Product Discontinuance Notification—PDN# 0000445504

We would like to inform you that the NPort 6000 and CN2500/CN2600 will reach its End of Life (EoL) phase, starting May 01, 2026.

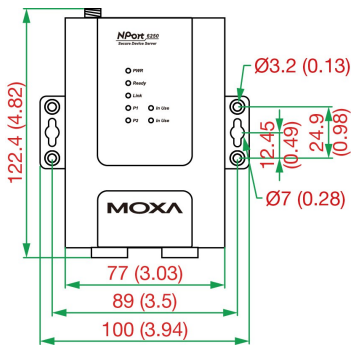
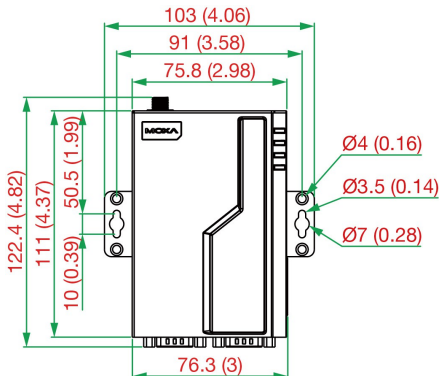
Specification	NPort 6250 (EoL)	NPort 6250-G2 (Replacement)
Dimensions (with ears)	100 x 122.4 x 29 mm  Front view dimensions: 122.4 (4.82) mm height, 77 (3.03) mm width, 89 (3.5) mm width, 100 (3.94) mm width. Mounting hole dimensions: Ø3.2 (0.13) mm, 12.45 (0.49) mm, 24.9 (0.98) mm, Ø7 (0.28) mm.	103 x 122.4 x 25 mm  Front view dimensions: 122.4 (4.82) mm height, 111 (4.37) mm height, 10 (0.39) mm height, 76.3 (3) mm width. Mounting hole dimensions: Ø4 (0.16) mm, Ø3.5 (0.14) mm, Ø7 (0.28) mm. Other dimensions: 103 (4.06) mm, 91 (3.58) mm, 75.8 (2.98) mm, 50.5 (1.99) mm.

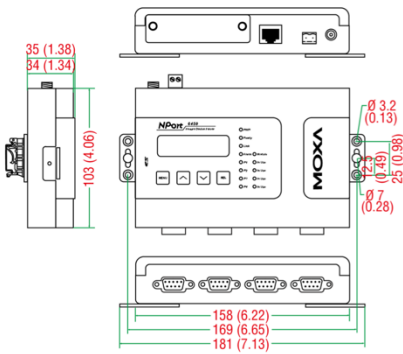
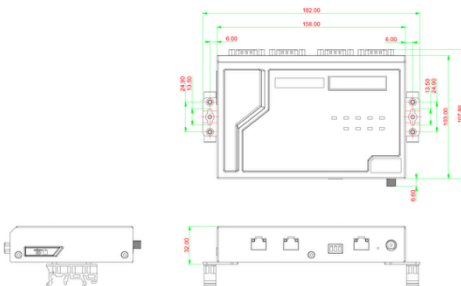
Specification	NPort 6450 (EoL)	NPort 6450-G2 (Replacement)
Dimensions (with ears)	120 x 181 x 35 mm Unit: mm (inch)  Front view dimensions: 158 (6.22) mm, 169 (6.65) mm, 181 (7.13) mm. Mounting hole dimensions: Ø3.2 (0.13) mm, Ø7 (0.28) mm, 25 (0.98) mm. Other dimensions: 35 (1.38) mm, 34 (1.34) mm, 103 (4.06) mm.	114.4 x 182 x 32 mm  Front view dimensions: 182 (7.17) mm, 114.4 (4.5) mm. Mounting hole dimensions: Ø3.2 (0.13) mm, Ø7 (0.28) mm, 25 (0.98) mm. Other dimensions: 158 (6.22) mm, 169 (6.65) mm, 181 (7.13) mm, 35 (1.38) mm, 34 (1.34) mm, 103 (4.06) mm.
